Item ID: D350-588-041 Accept ***N900040100*** Setup Start ***NS1***
 Revision ID: Stop ***NS2***
 Item Name: Aft Door Assembly
 Start Date: 2/11/2016 Start Qty: 1.00 ***1*** Cust Item ID:
 Required Date: 2/18/2016 Req'd Qty: 1.00 ***1*** Customer:
 Reference:

DART SERVICE INSTRUCTION

TO AMEND INSTALLATION INSTRUCTIONS D350-588 REV. D AND
INSTRUCTIONS FOR CONTINUED AIRWORTHINESS ICA-D350-588 REV. D
REF TCCA STC SH92-41
FAA STC SH1012NE

The purpose of this Dart Service Instruction is to provide customers with directions to install a modified striker plate that will provide more clearance around environmental/conductive seals that protrude inboard of the door frame structure on AS355 N/NP models.

Figure 1 Striker Plate

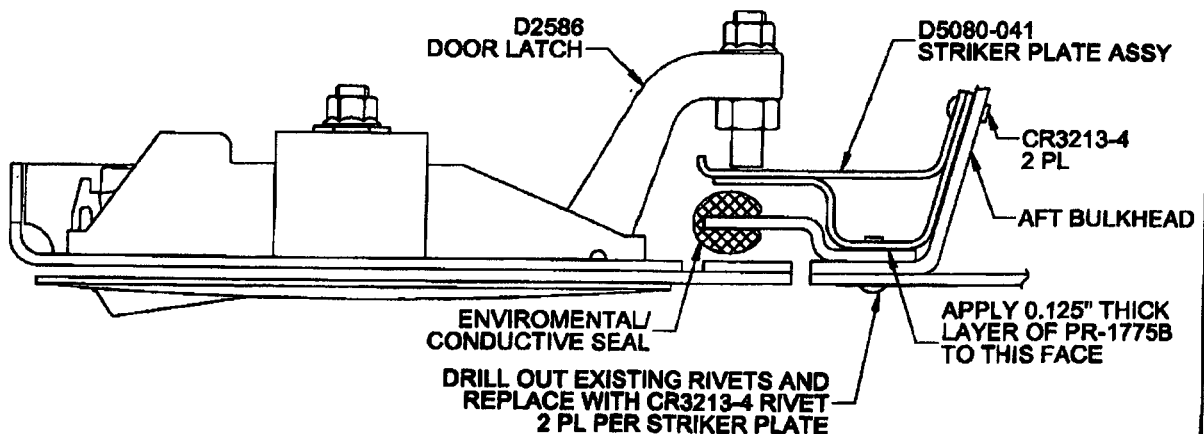
- 5) Align D5080-041 striker plate assembly in the previously marked location and transfer drill the $\varnothing 0.1285"$ (#30) holes into the aft bulkhead.

- 8) Deburr holes and remove all sharp edges.
- 9) Touch up all holes in aluminum with chemical conversion coating in accordance with MIL-DTL-5541.
- 10) Apply 0.125" thick layer of PR-1775B ProSeal to the face of D5080-041 per Figure 1.

- 11) Install D5080-041 striker plate assemblies to the aft bulkhead using CR3213-4 rivets of a suitable length, and to the skin of the aircraft using PR-1775B coated CR3213-4 rivets of a suitable length.

588 -041	588 -011	PART NUMBER	DESCRIPTION
X		D350-588-041	AFT DOOR ASSEMBLY
	X	D350-588-011	AFT DOOR FWD HINGE MOD
2	2	D5080-041	STRIKER PLATE ASSY (AS355 N/NP MODELS ONLY)
2	2	D2237	STRIKER PLATE
